June 29, 2001

JB 18457-I

Addendum Geologic and Soils Engineering Exploration Report #2
Proposed Landslide Repair and Multi-Unit Condominium and Town Home Buildings
Tentative Tract 52928
17331-17333 Tramonto Drive
Pacific Palisades, California

Grading Section Log # 31587-01

SECTION O-O

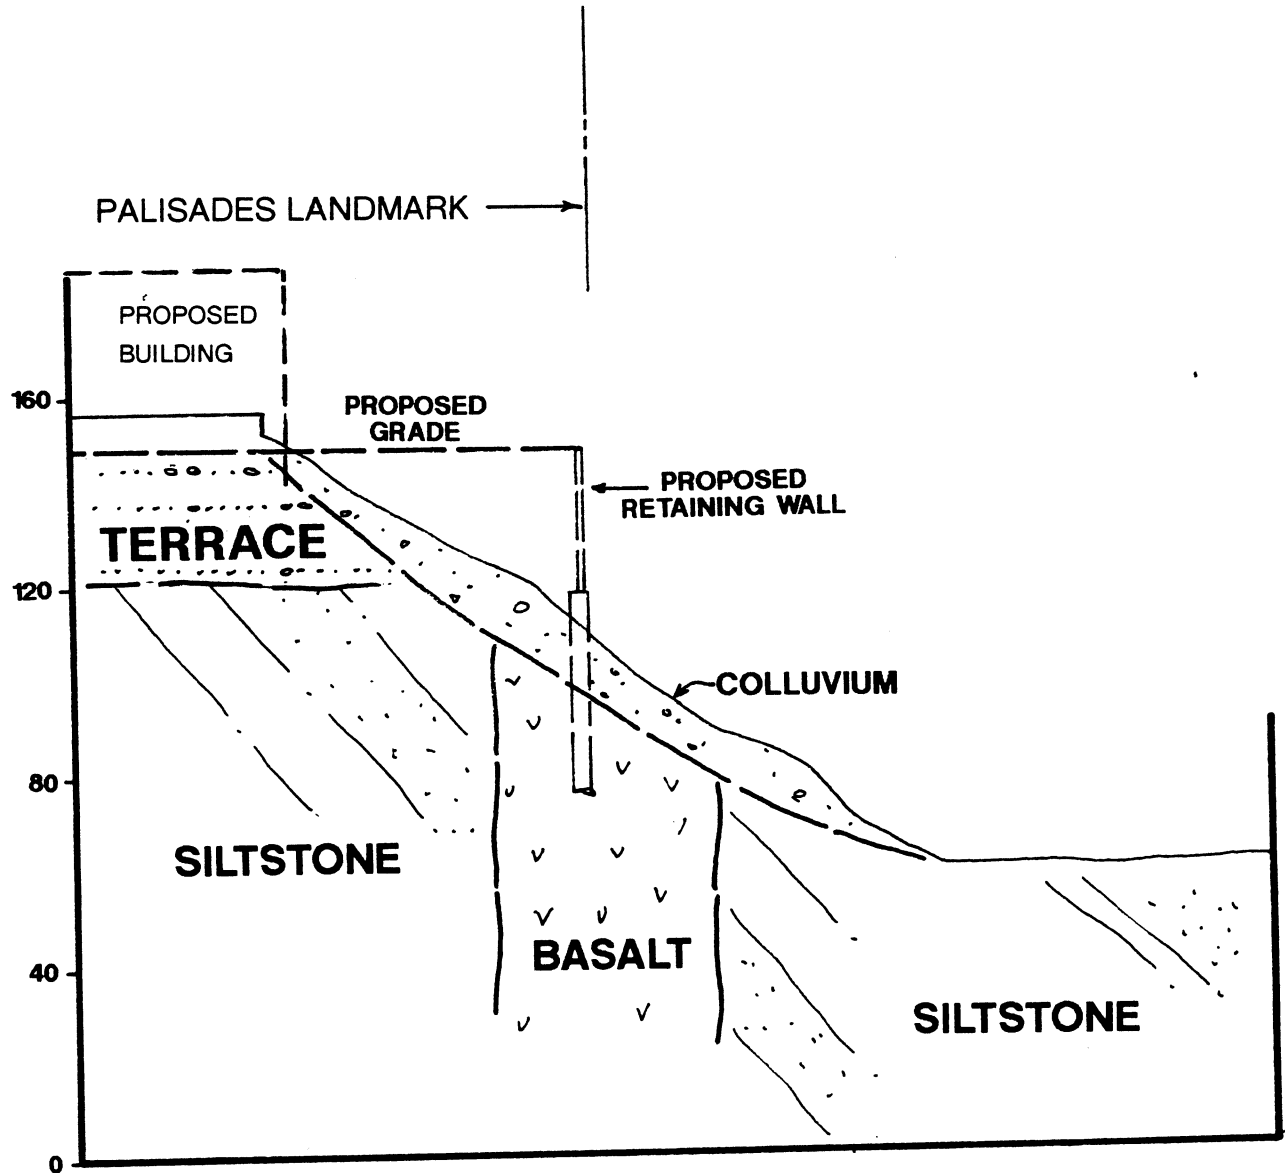
Item 12 - *Design calculations and recommendations for the retaining wall that will support fifty feet of fill on section O. Explain, why the height of the wall is shown to be 50 feet (down to soil/bedrock contact) if no exploration determining the thickness of colluvium at this location was conducted. Also, show location of the proposed building.*

The thickness of the colluvium was conservatively estimated at 10 to 15 feet. Therefore, assuming at the highest point the planned grade is 35 feet above the ground surface, the retaining wall could retain up to 50 feet of compacted fill. The actual thickness of the colluvium will be verified during construction. The enclosed calculations indicate that retaining walls supporting compacted fill with a level backslope, higher than 15 feet and up to 50 feet, may be designed for an equivalent fluid pressure of 55 pcf.

The upslope building is shown on Section O and is located mostly on alluvial terrace. Footings may have to be deepened in places to reach the terrace.

SECTION P-P

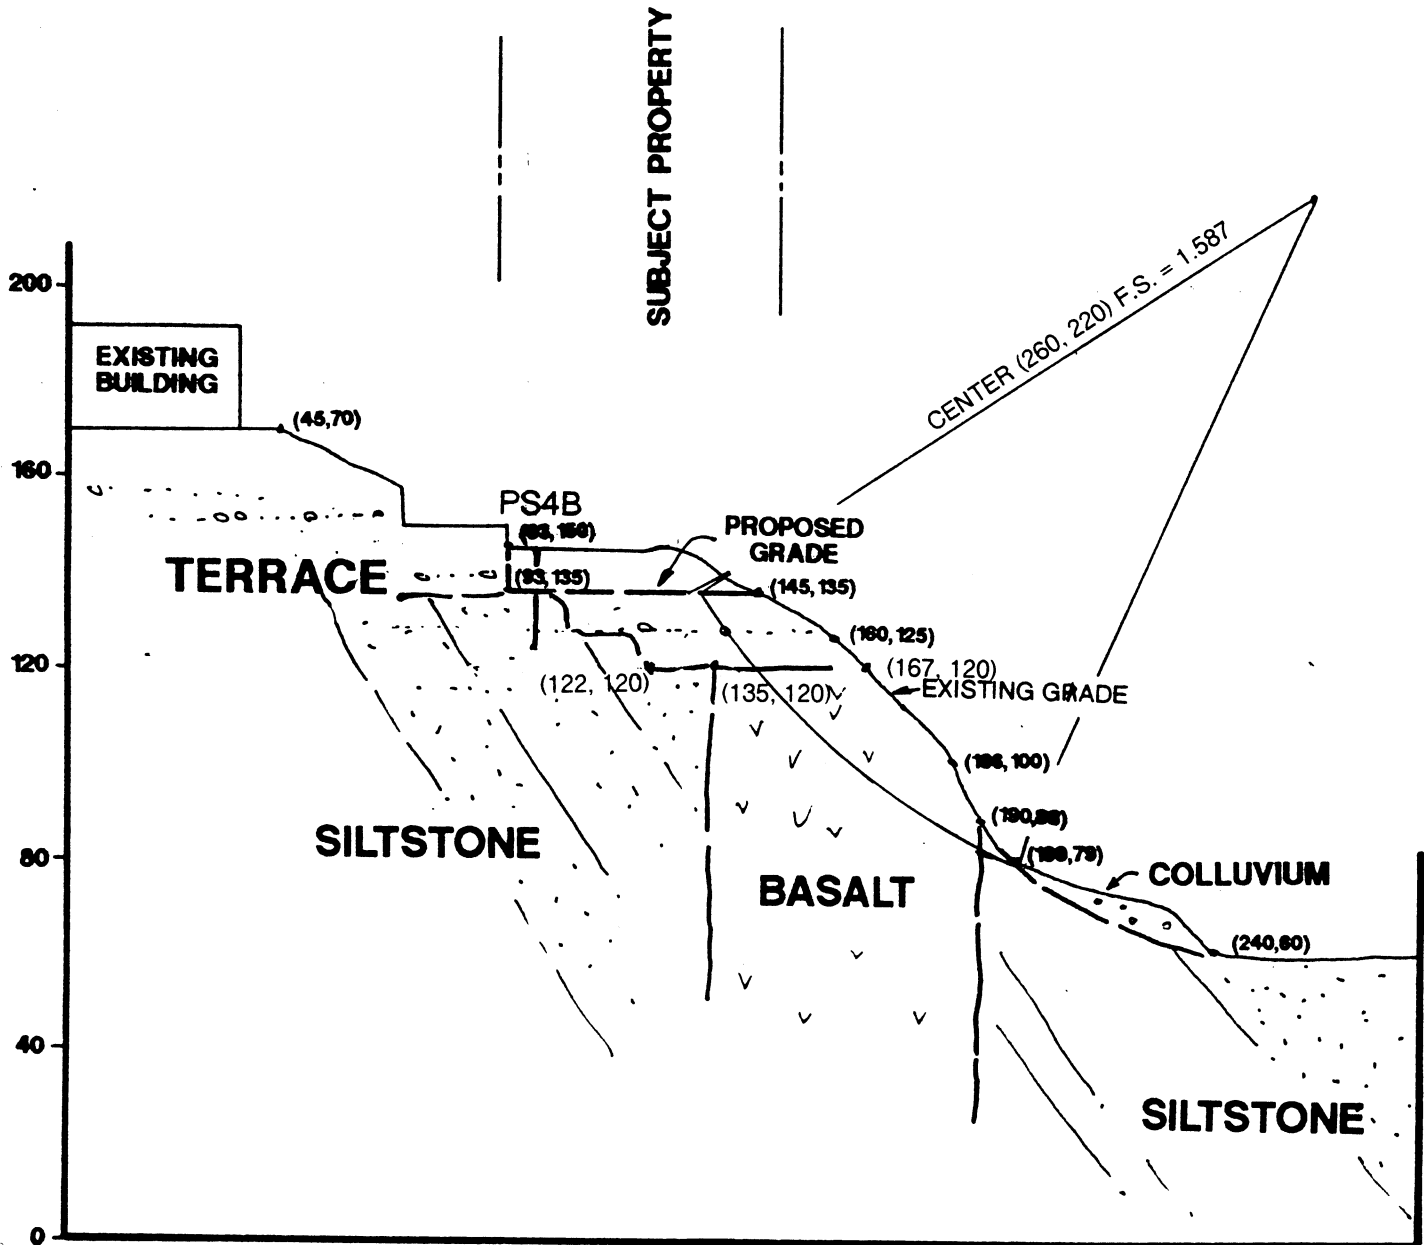
Item 13 - *Slope stability calculations for cross-section P are based on shear strength of siltstone bedrock. However the existing soils comprise of terrace deposits and basalt, please clarify.*

The November 29, 2000 addendum report referenced a Geosoils report for the property located at 17315 Sunset Boulevard (intersection of Sunset Boulevard and Los Liones Drive). Shear Diagram SH-2 from their report indicates a cohesion value/phi angle combination of 750 psf/33 degrees for the basalt. A study of the Pacific Palisades by Moran, Proctor, Muesser & Rutledge, 1959 (*Final Report, Pacific Palisades Landslide Study*) contains shear test results of nearby terrace. They report a cohesion value/phi angle combination of 550 psf/20.5 degrees for nearby terrace. The stability of

Section P was re-analyzed using these values, which appear reasonable for the area. Calculation Sheets 9 through 11 show that the steep basalt slope depicted in Section P is grossly stable.

SECTION Q-Q

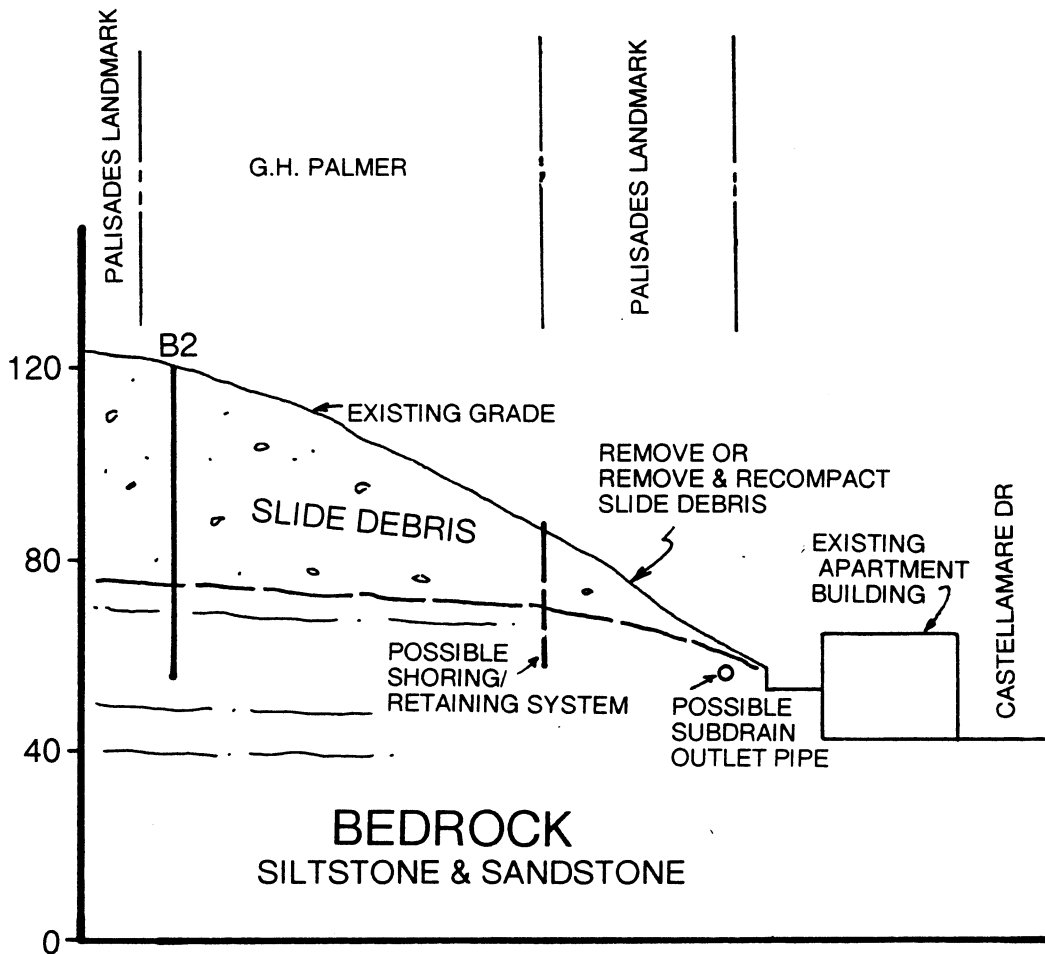
Item 14 - *Show the locations for sections Q and R on the map and complete the sections with geologic information.*

Sections Q and R were erroneously included in the last report. These sections were not intended to show the existing geologic structure and the proposed development. Section Q is now located through the strip of land that extends through building the existing building to Castellamarre Drive (see response to Item 3).

CHIMNEY DRAIN DETAIL

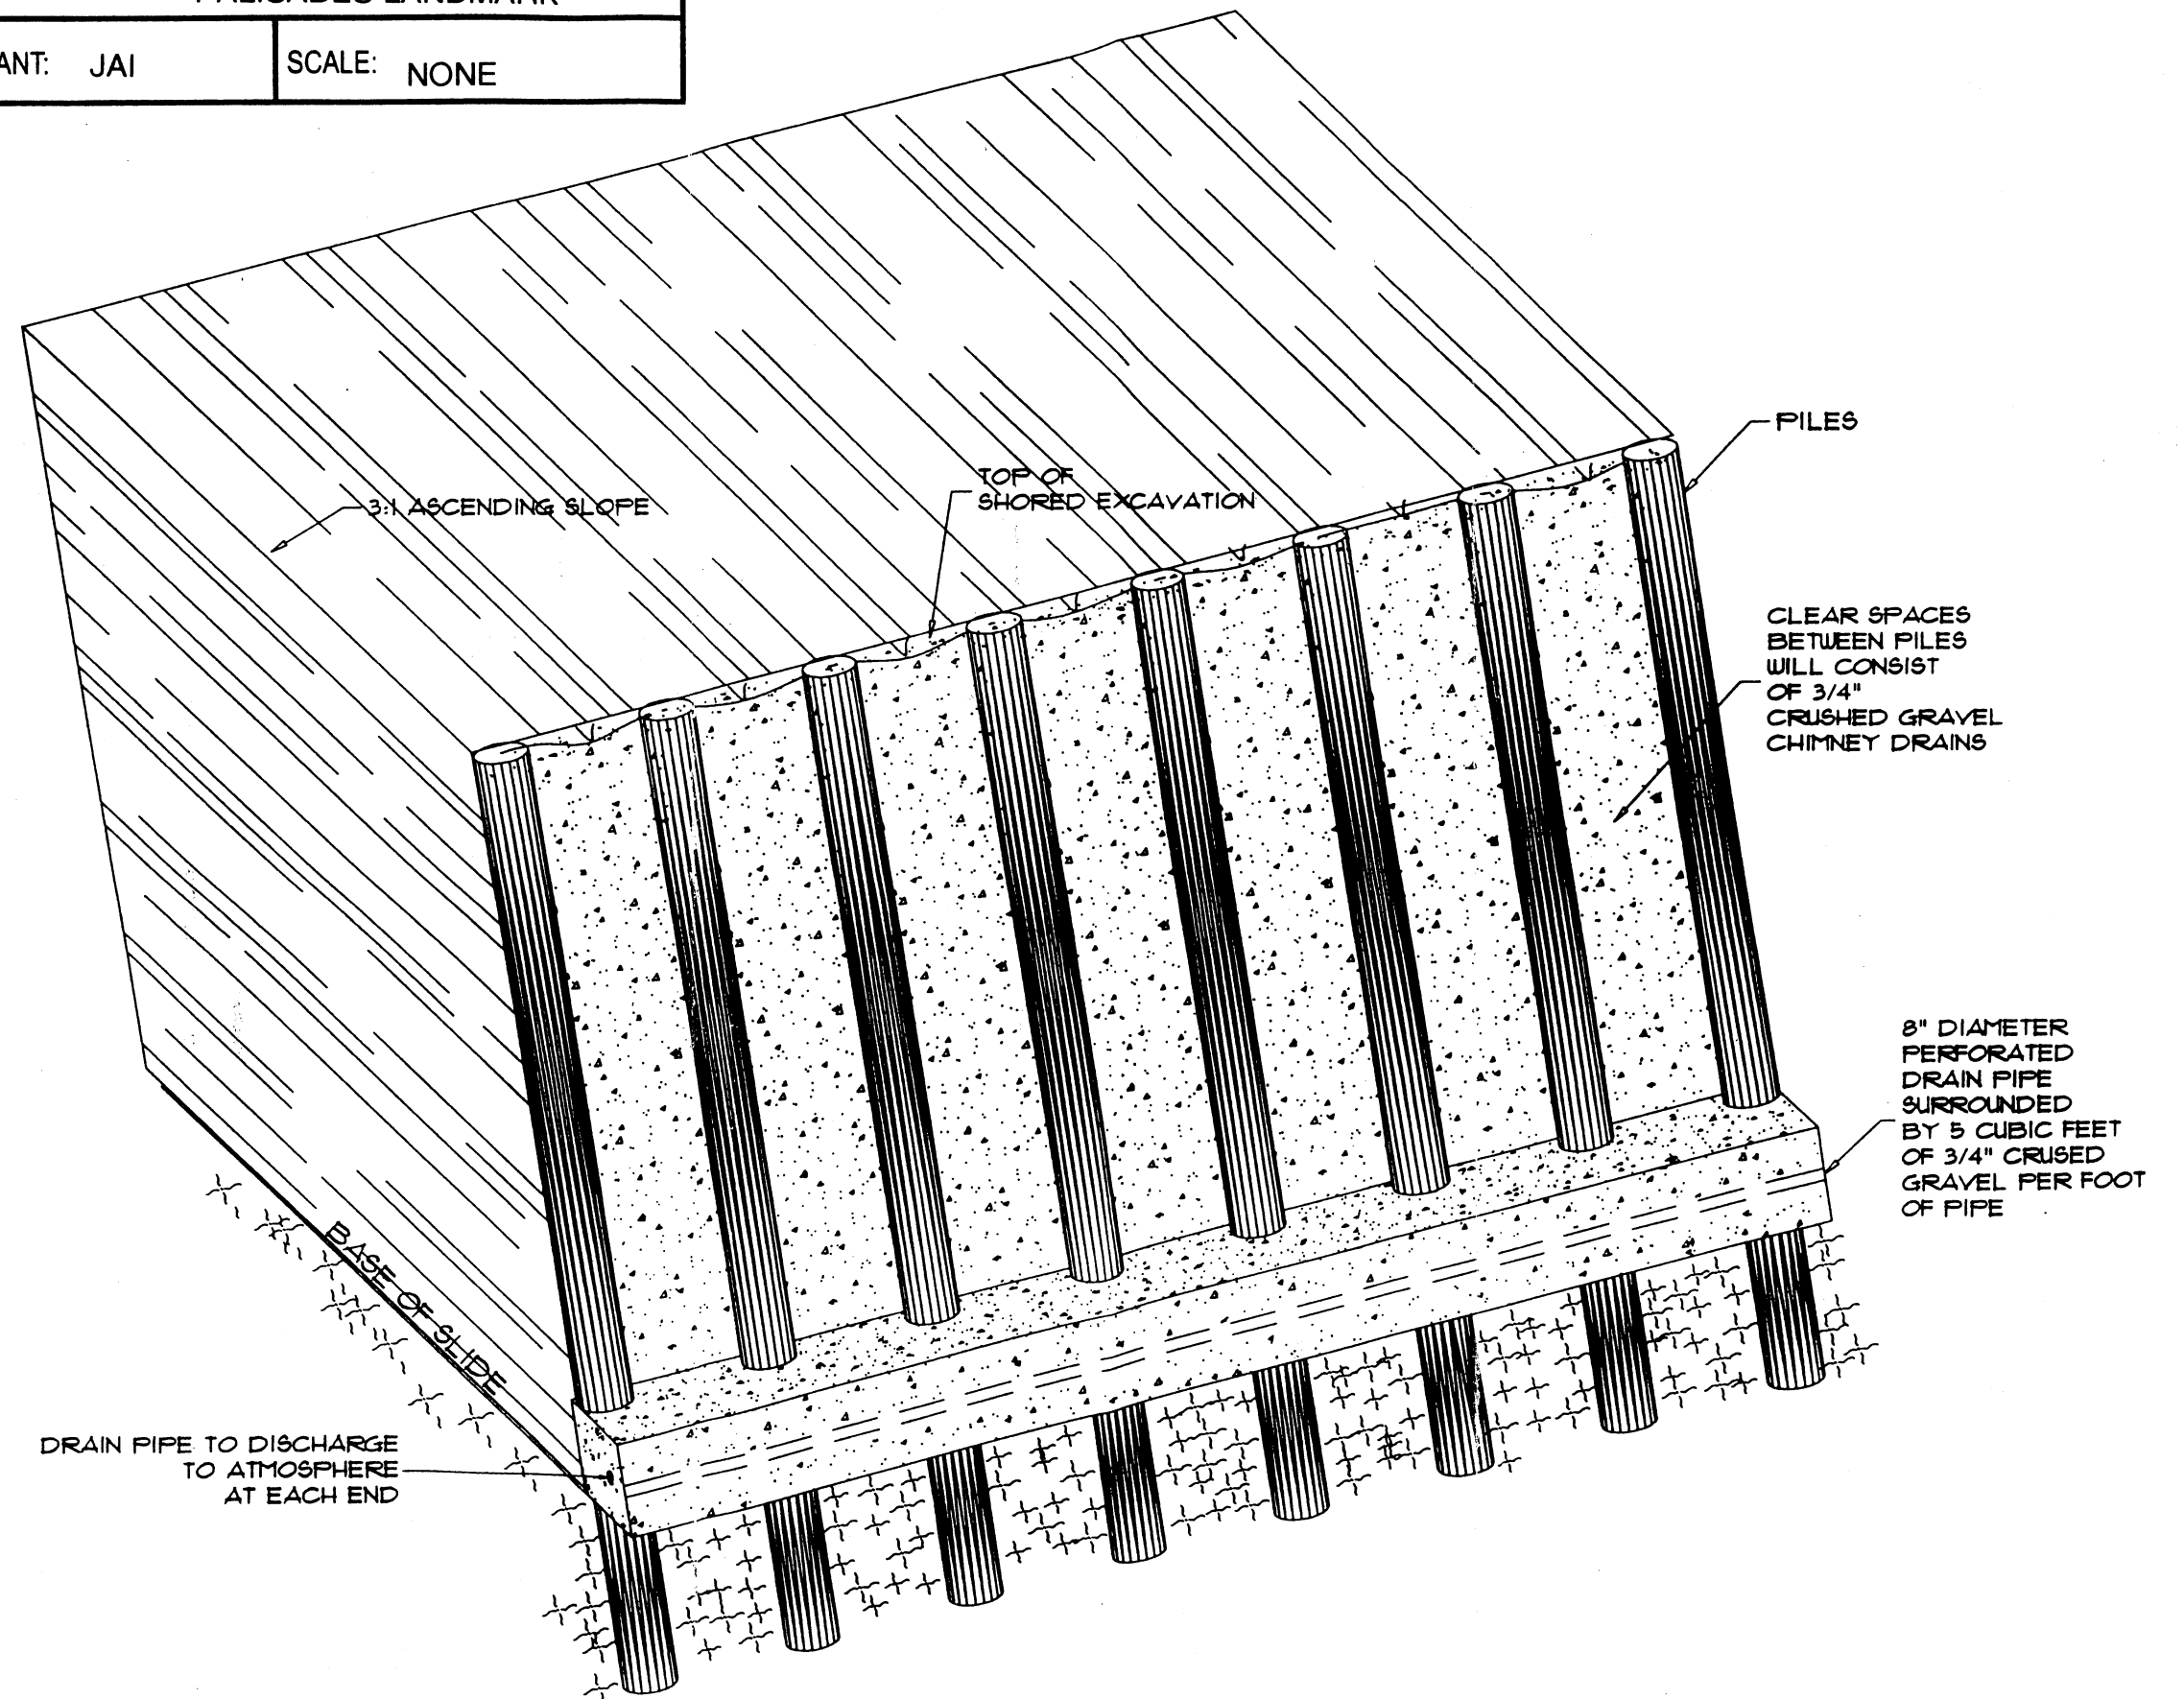
Item 18 - *Show de-watering system on the cross-sections for all soldier pile/retaining structures.*

Typical subdrains are shown on the revised sections. Also, the Chimney Drain Detail shows the recommended drain at the soldier piles along the uphill side of the repair. It is our understanding, that the civil engineer will prepare a formal subdrain plan upon approval of the Tentative Tract.
